Access Compliance Report

Public Rights-of-Way

(Curb Ramps)

Intersection ID: 20185	Main Street: FAIRVIEW_RD	Cross Street: PIEDMONT_ROW_DR	Location: NE
ADA ID: 86526991D105	Ramp Type: Perp	Initial Pass/Fail: Fail	Overall Compliance: No
		Severity Score: 12.5

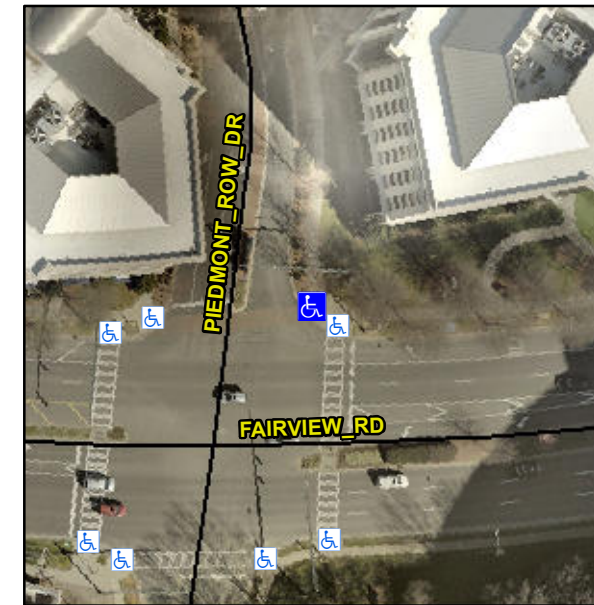
Not Found, R304.2.2

Compliance	Description	Data	Compliance	Description	Data
N/A	Ramp Length (in)	94.0	No	Ramp Slope (%)	10.1
Yes	Ramp Width (in)	48.0	Yes	Ramp XSlope (%)	0.4
N/A	Flare Type LT	N/A	N/A	Flare Type RT	N/A
N/A	Flare Slope LT (%)	N/A	N/A	Flare Slope RT (%)	N/A
N/A	Flare Traversable LT?	N/A	N/A	Flare Traversable RT?	N/A
N/A	Landing Length (in)	N/A	N/A	DWS Provided?	N/A
N/A	Landing Width (in)	N/A	N/A	DWS Contrast?	N/A
N/A	Landing Slope (%)	N/A	N/A	DWS Length (in)	N/A
N/A	Landing X Slope (%)	N/A	N/A	DWS Full Width?	N/A
N/A	Landing Curb? (Y/N)	N/A	N/A	DWS Offset (in)	N/A
N/A	Shared Landing?	N/A			
N/A	Gutter Ponding?	N/A	N/A	Gutter Slope (%)	N/A
N/A	Gutter Lip Ht (in)	N/A	N/A	Gutter X Slope (%)	N/A
N/A	Painted X Walk1?	Yes	N/A	Painted X Walk2?	N/A
	X Walk 1 Direction	To NW		X Walk 2 Direction	N/A
N/A	X Walk 1 Width (in)	110.0	N/A	X Walk 2 Width (in)	N/A
	X Walk 1 Slope (%)	3.3		X Walk 2 Slope (%)	N/A
	X Walk 1 X Slope (%)	2.8		X Walk 2 X Slope (%)	N/A

Remove & Replace Entire Ramp.
